Appendix N
Draft EIS Comments and Responses

APPENDIX N DRAFT EIS COMMENTS AND RESPONSES

N.1 PUBLIC AND AGENCY COMMENT SUMMARY

Map of Historic Eagle Nest Locations

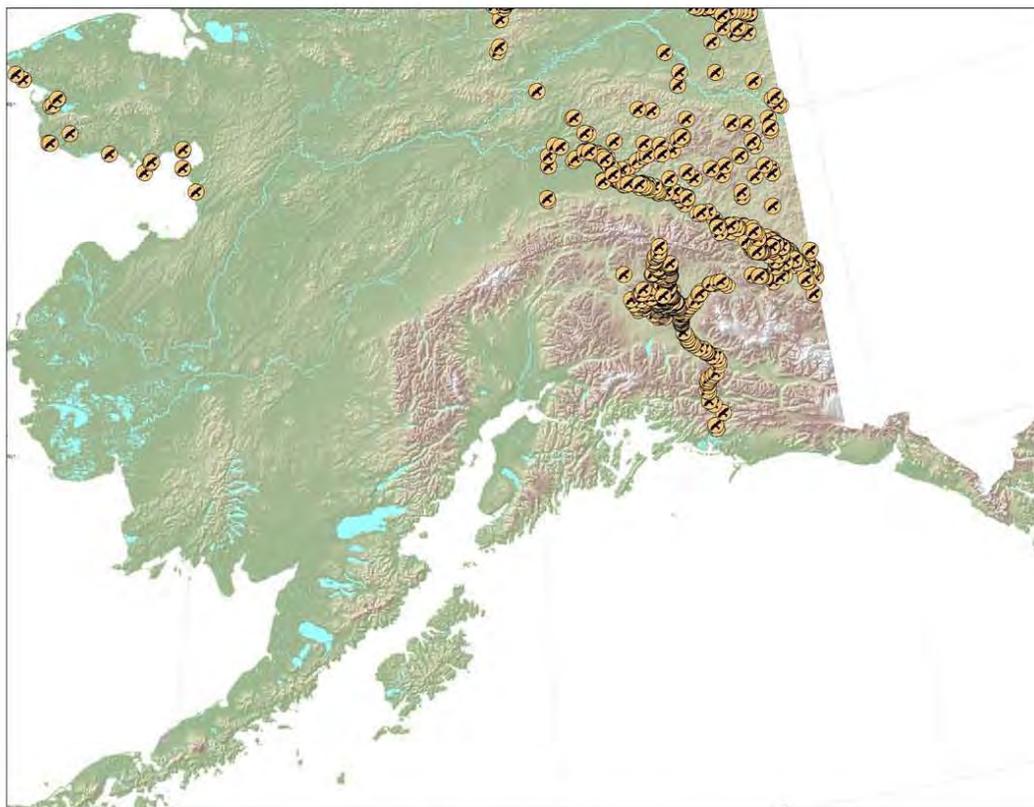
NOTE: GIS shape files and maps to be used in analysis for the Final EIS are available through the Fairbanks Fish and Wildlife Service Field Office. Please contact Jewel Bennett at 907-456-0324.

Figure 1 Susitna Watana Project Area

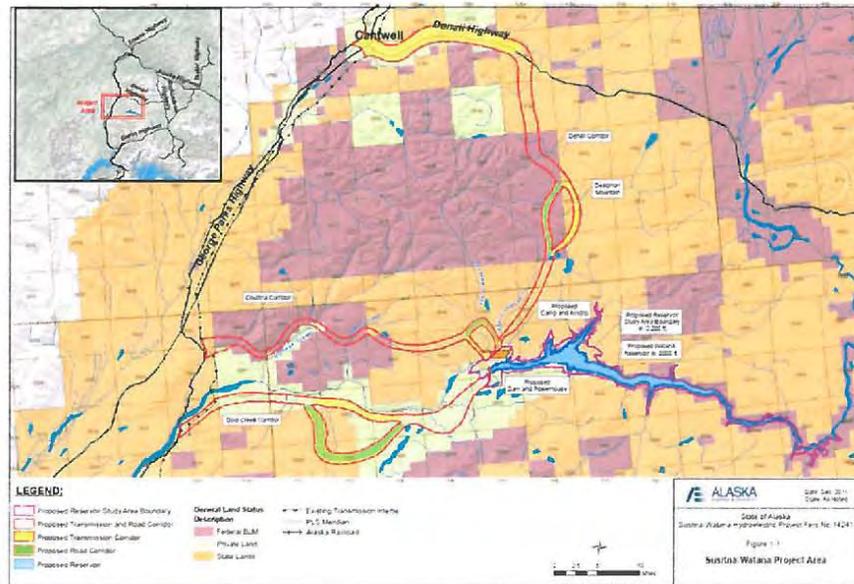
Three possible alternatives for access roads and transmission lines have been identified for the Project (Figure 1). Two of the alternatives would accommodate east-west running transmission lines in combination with a new site access road connecting to the Anchorage-Fairbanks Intertie Transmission line and the Alaska Railroad. One of these corridors, designated as the Chulitna Corridor, would run north of the Susitna River, and extend to the Chulitna siding area. The other alternative, designated as the Gold Creek Corridor, would run south of the Susitna River, and extend to the Gold Creek area. A third corridor, designated as the Denali Corridor, would run due north, connecting the Project site to the Denali Highway by road over a distance of about 44 mi. If a transmission line is constructed along this corridor, it would be extended westward along the existing Denali Highway and connect to the Alaska Intertie near Cantwell.

Figure 2 Project Site

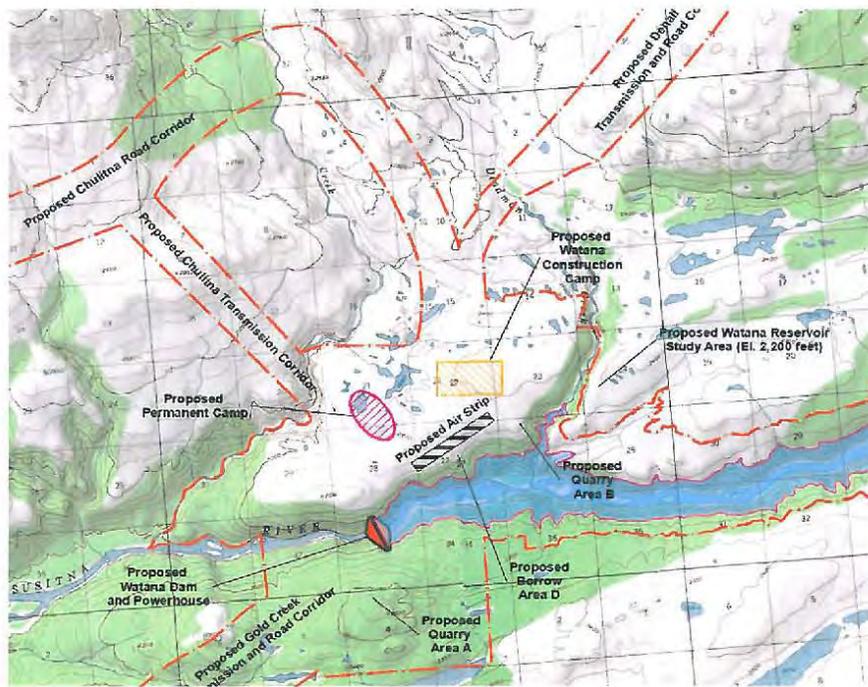
The most significant item among the temporary site facilities will be a construction camp (Figure 2). The construction camp will be a largely self-sufficient community normally housing approximately 800 persons, but with a peak capacity of up to 1,000 people during construction of the Project. After construction, it is planned to remove most of the camp facility, leaving only those aspects that are to be used to support the smaller permanent residential and operation and maintenance facilities.

AEA plans to construct a 7000-foot long runway that would accommodate Boeing 737 aircraft (Figure 2). The runway would like be constructed on the north side of the Susitna River, east of the proposed dam site.
